Re: SCP - Carlstadt, New Jersey

SUBJECT: SCP CARLSTADT DRAFT PROJECT OPERATIONS PLAN (DPOP)

Comments on the Remedial Investigation
and Feasibility Study of the
SCP Carlstadt Site

SUBJECT: DRAFT RI/FS on the SCP CARLSTADT SITE

003121
APPROXIMATE LOCATIONS
ADDITIONAL SOIL BORINGS

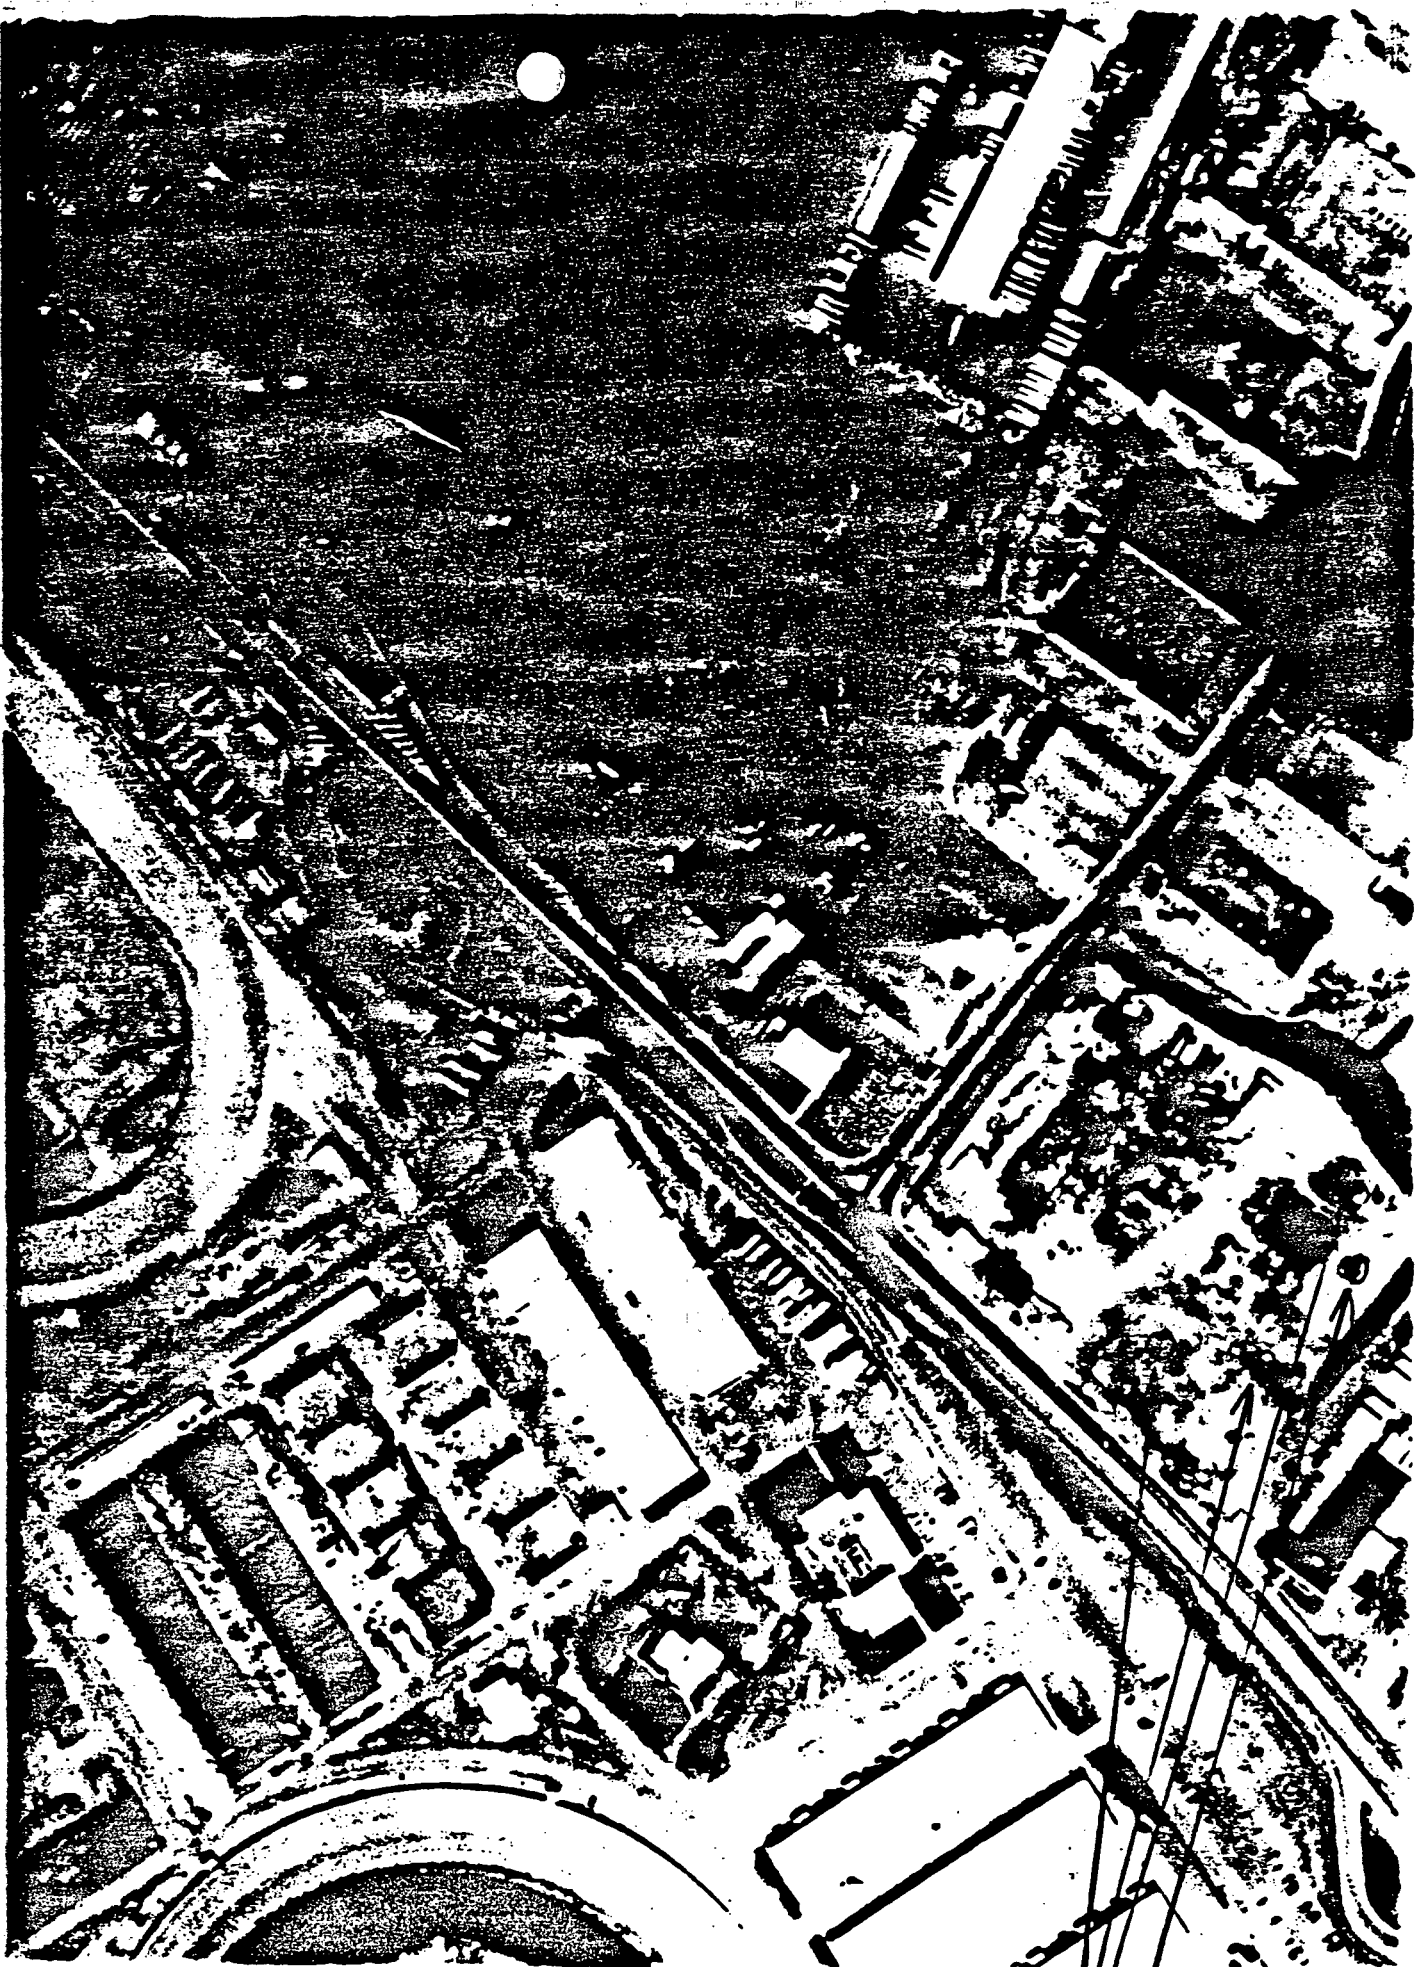
1. Analysis of 1979 aerial photographs indicated the presence of 2 suspicious areas adjacent to the known lagoon in the northeastern corner of the site. Further sampling should be done in these suspected areas. Two additional borings should be adequate. An additional two borings should also be made in the southern quadrant of the site to better characterize that area (Attachment A). Samples should be taken and analysed consistent with other borings on the site. The total number of sample locations is thus raised to 19.
